**From:** James Cox  
**Sent:** 02 April 2019 08:51  
**To:** Rob Smith  
**Subject:** RE: Woodsmith Mine - NYM/2019/0129/NM [NLP-DMS.FID262297]

Further to your email below, please find attached final revised drawings to reflect a RAL 7016 finish on the roof.

Project: **653 York Potash**  
 Drawing Title: Mining Buildings Elevation Study - Colour  
 Scale: 1 : 50 @ A1  
 Drwg. Created: June 2014

DRAWING TITLE: Production Shaft Setting Out Elevations

Drwg. No: **653-AP-0058**  
 Status: **Issue**  
 (Not for Construction)  
 Revision: **10**

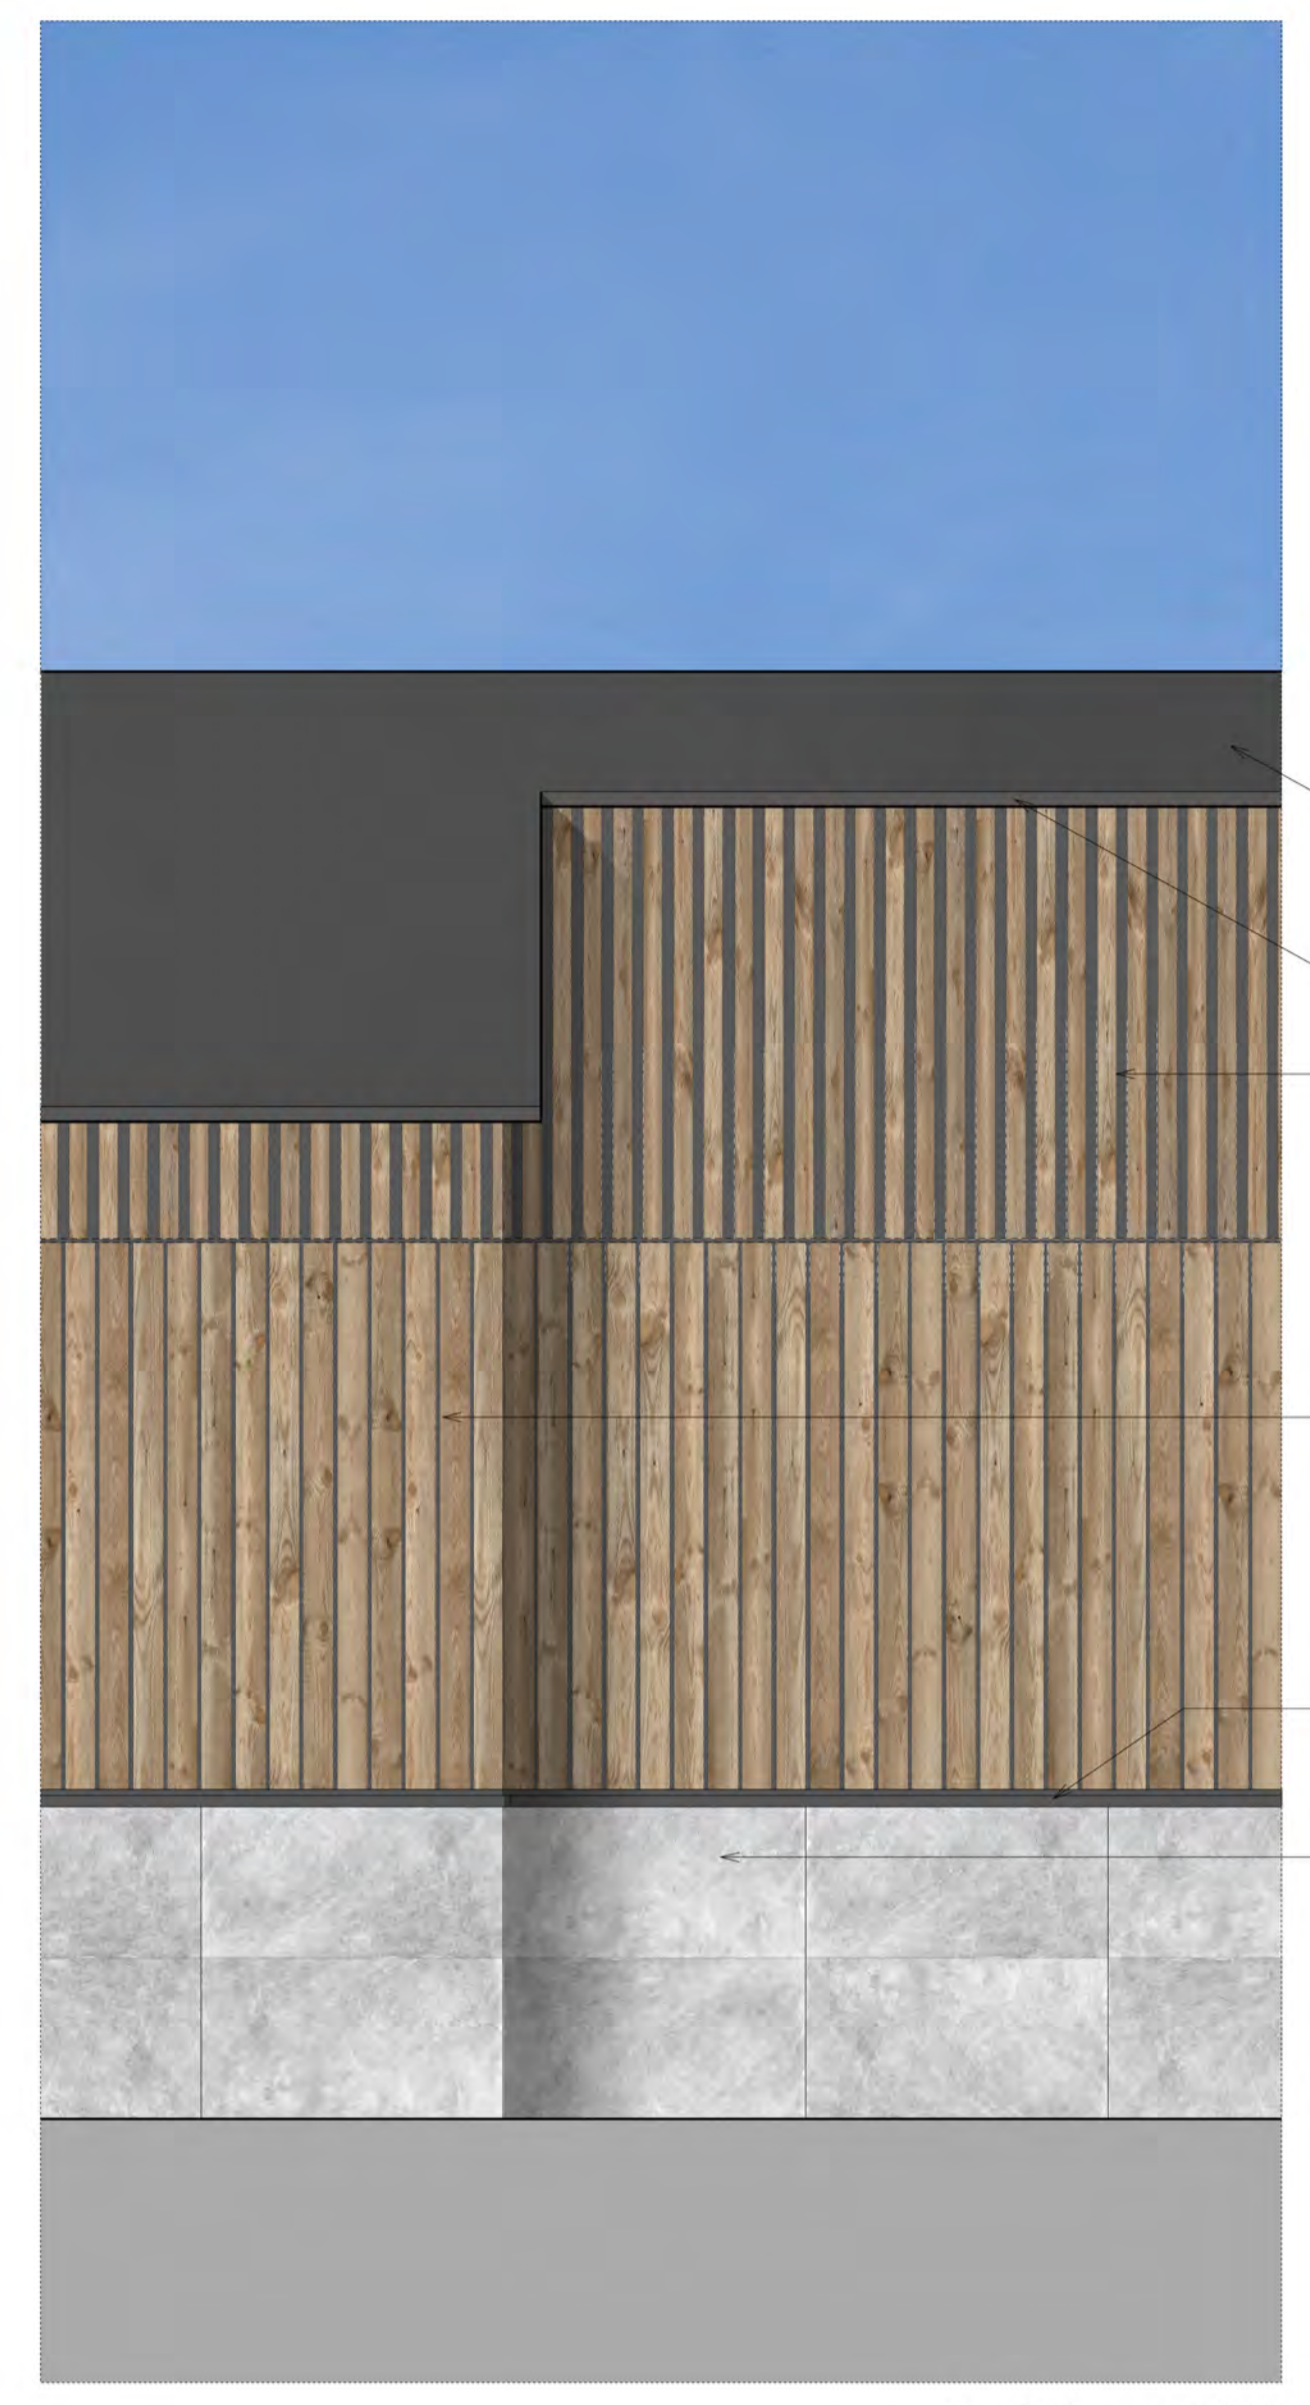
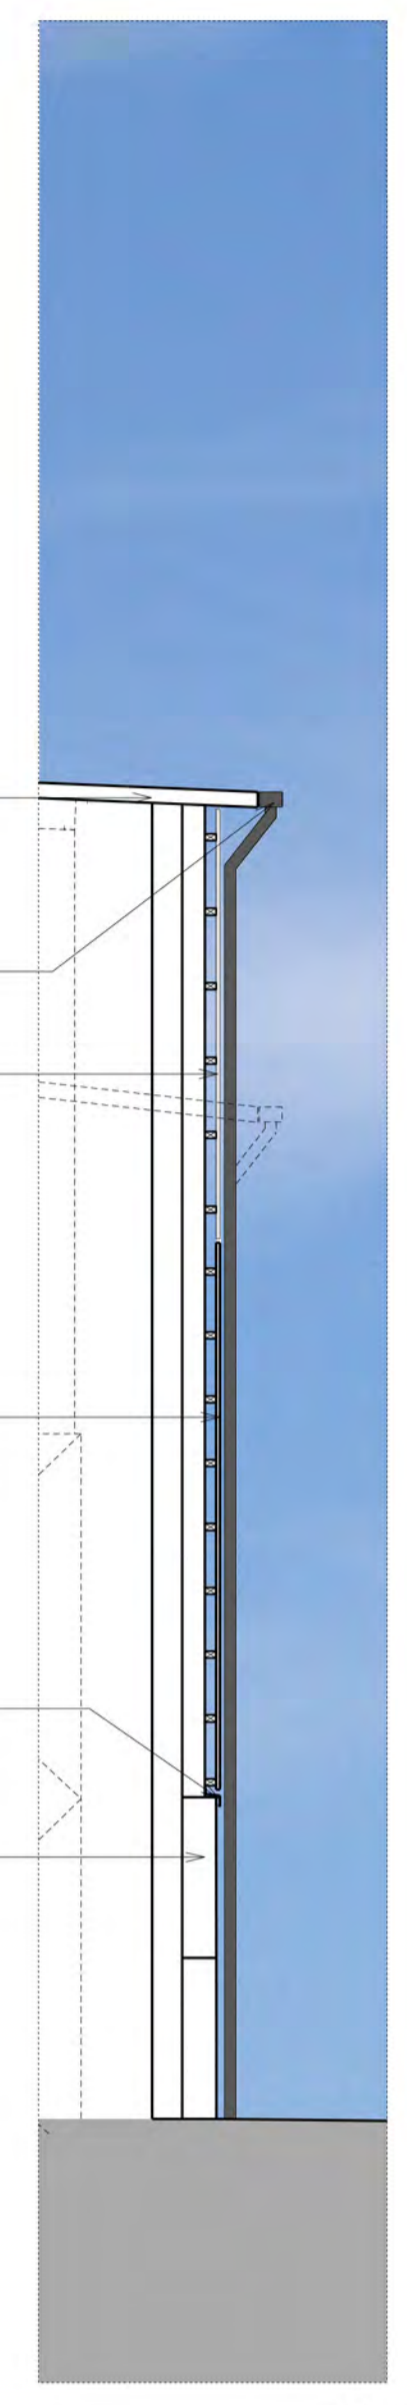
Date:	Rev:	Note:	Check:
25.09.14	0	Planning Issue	PC
11.02.15	1	Updated in accordance with NLP's Schedule of Changes for the SEI submission.	IWA
21.08.15	2	Updated cladding material following planning review.	IWA
25.09.15	3	Updated cladding detail following planning review.	IWA
06.06.17	4	Updated for Section 73 Application June 2017, in accordance with Planning Review dated 26.05.17	IWA
22.02.19	5	Updated for planning purposes	IW
05.03.19	6	Roof RAL colour amended	IW
12.03.19	7	RAL colours updated	IW
21.03.19	8	Timber cladding updated	IW
25.03.19	9	RAL colour updated	IW
01.04.19	10	Roof RAL colour updated	IW

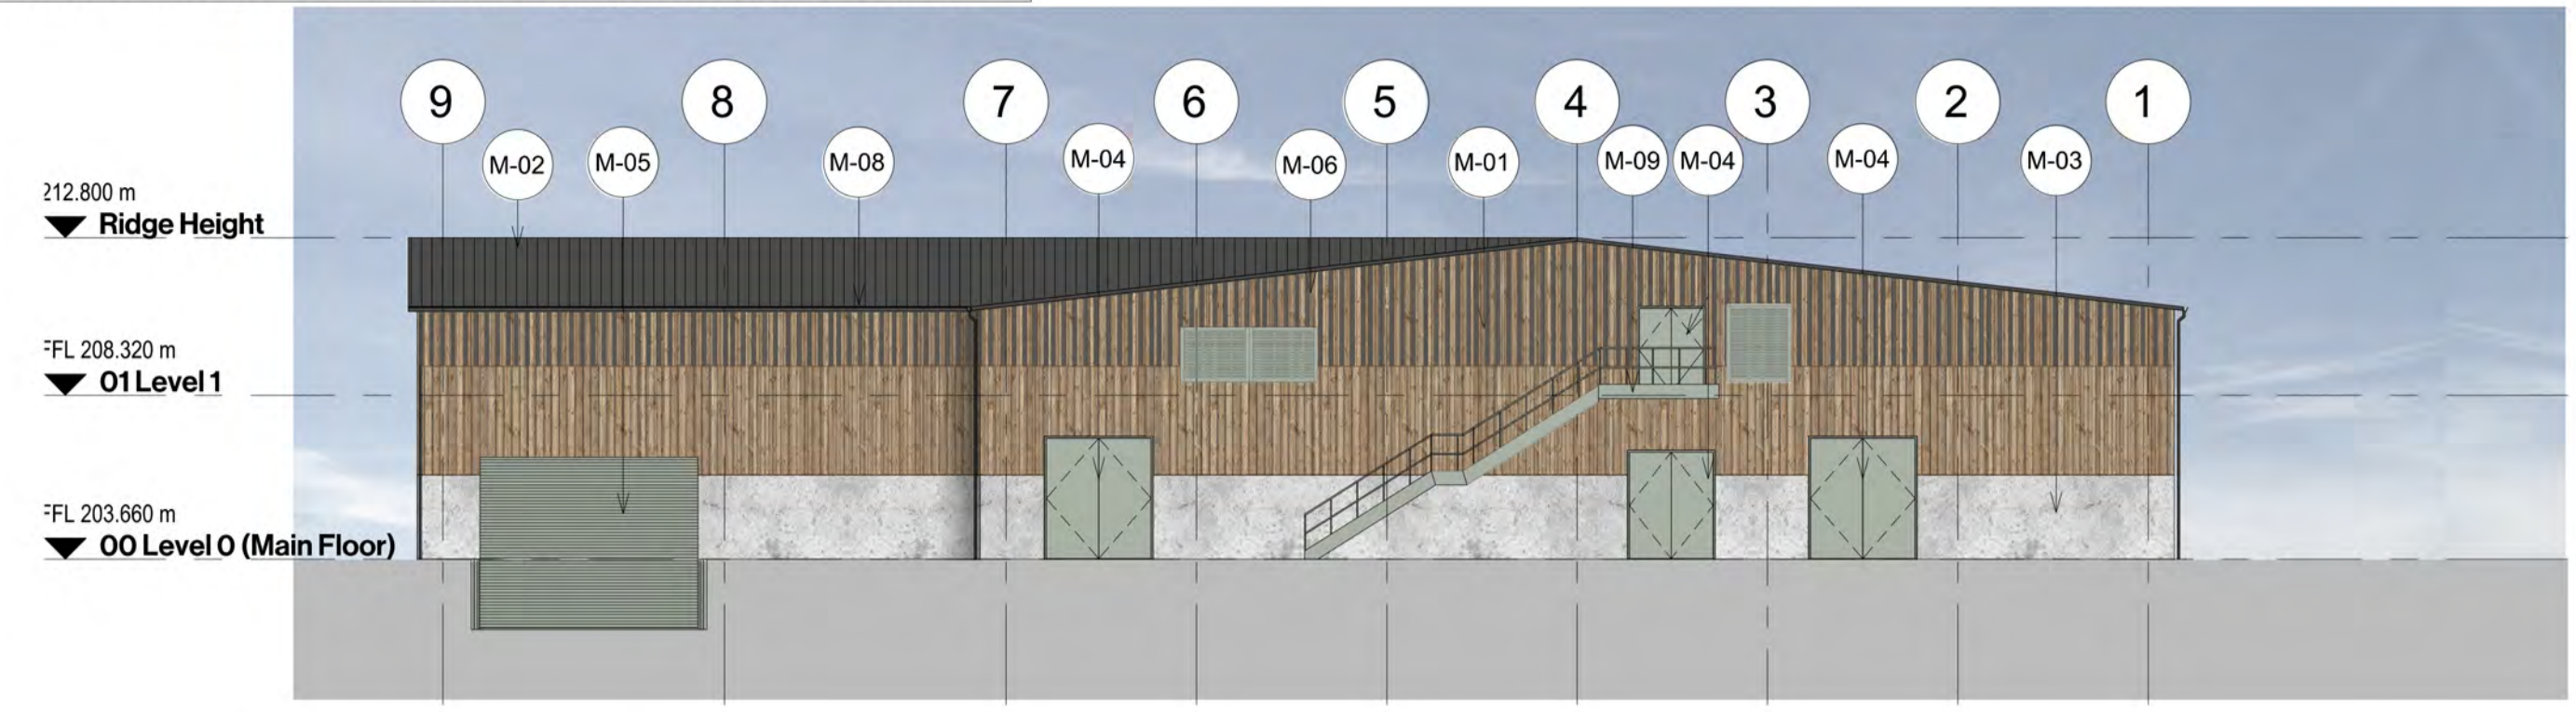
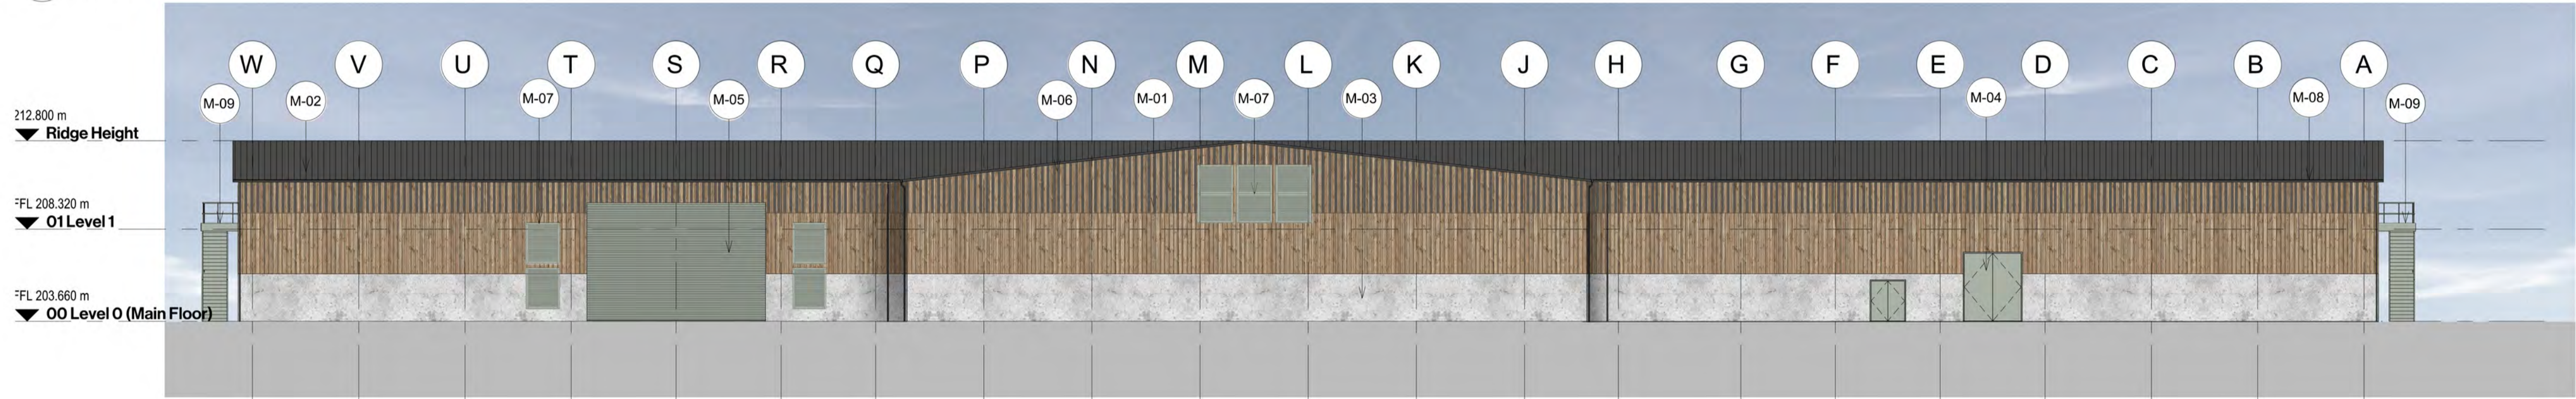
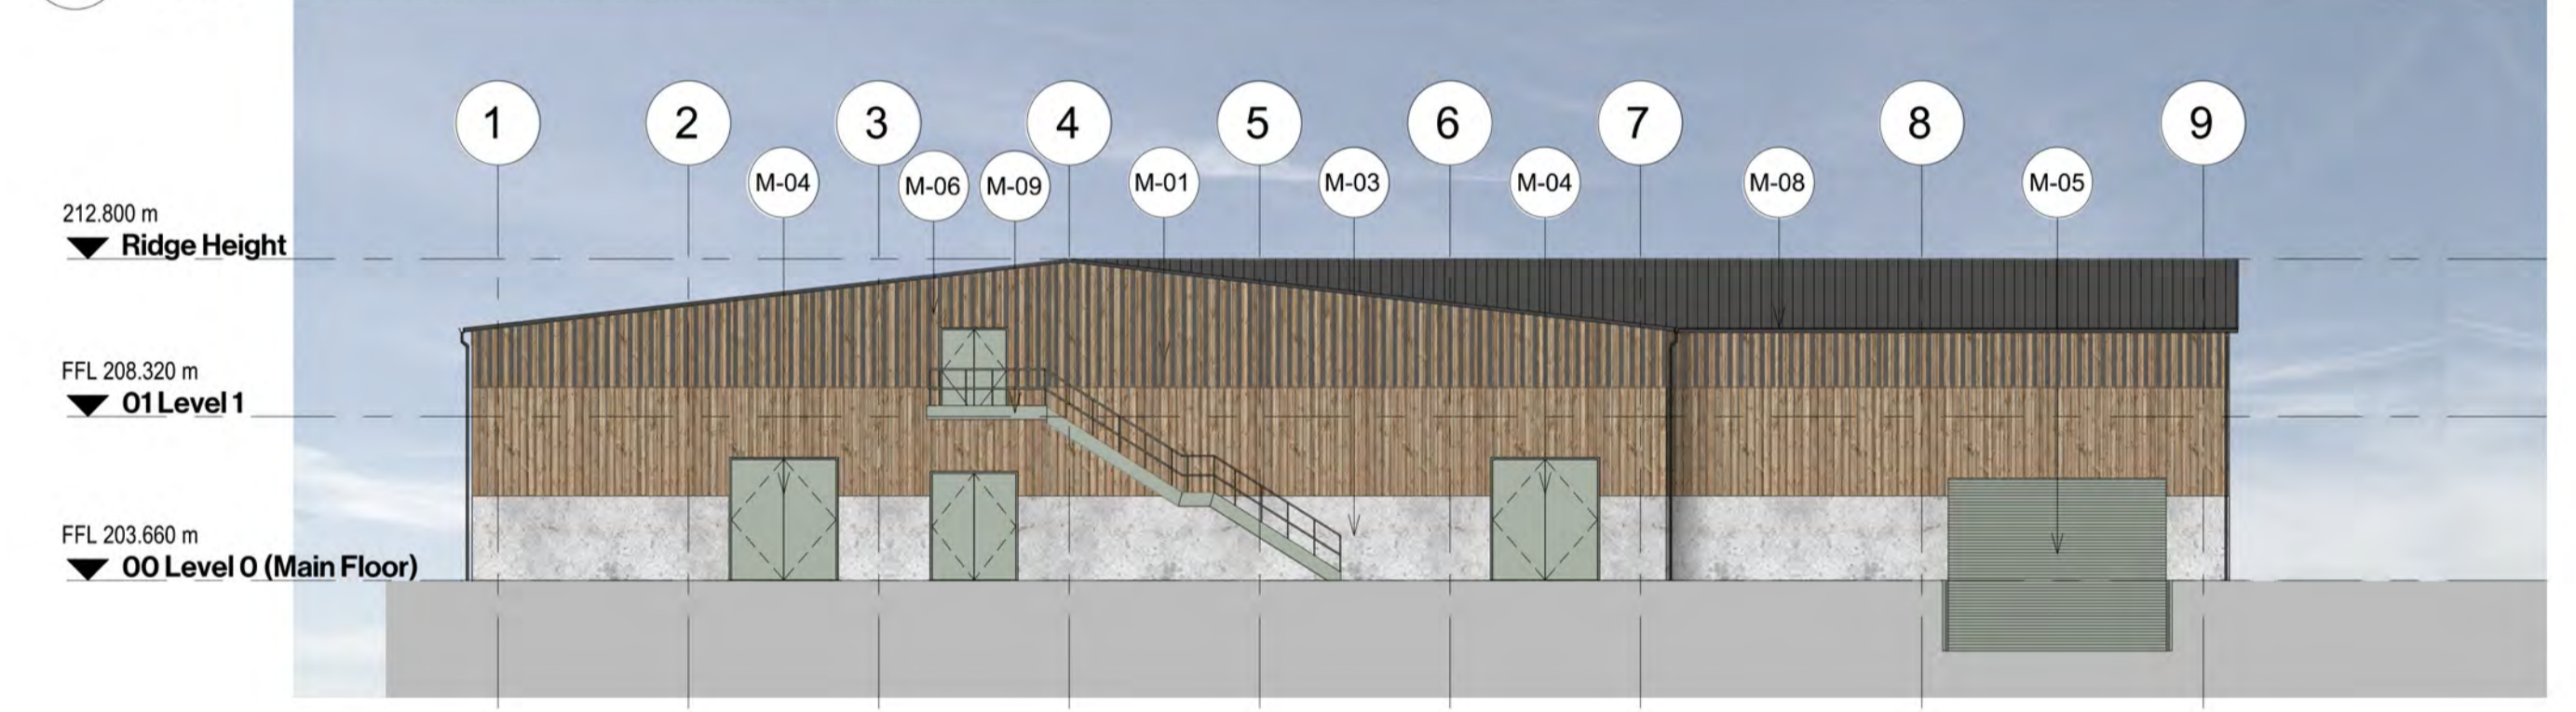
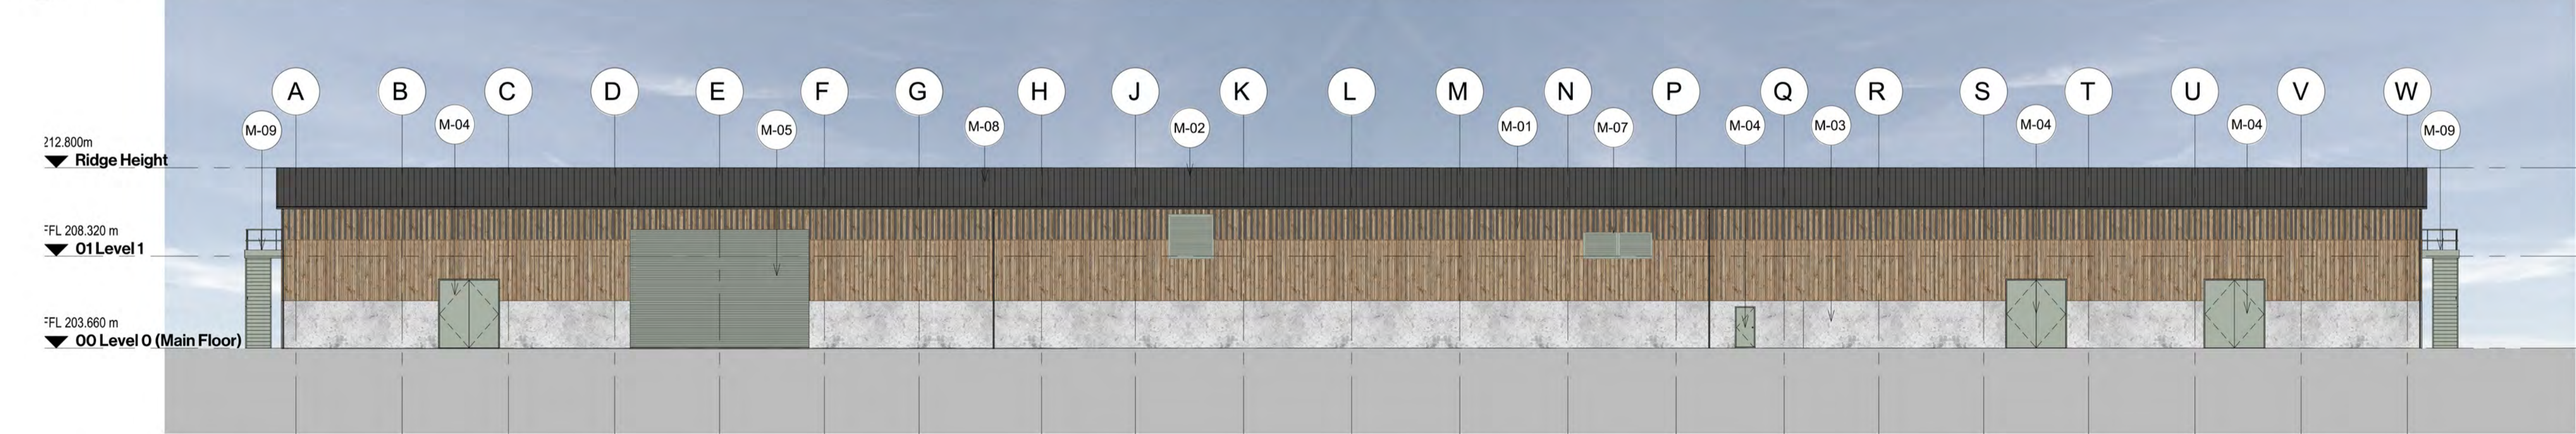
REVISION	DESCRIPTION	DATE	BY	CHKD	APPD
J	ROOF RAL COLOUR UPDATED	01/04/19	AK	JS	IW
H	RAL COLOUR UPDATED	25/03/19	AK	JS	IW
G	TIMBER CLADDING AMENDED	20/03/19	AK	JS	IW
F	RAL COLOURS UPDATED	11/03/19	AK	JS	IW
E	RAL COLOUR AMENDED	05/03/19	AK	JS	IW
D	AMENDED FURTHER TO COMMENTS	22/02/19	AK	JS	IW
C	AMENDED FURTHER TO COMMENTS	19/02/19	AK	JS	IW
B	TIMBER CLADDING AMENDED	19/02/19	AK	JS	IW
A	UPDATED TO SHOW PITCH COMPARISON	13/02/19	AK	JS	IW
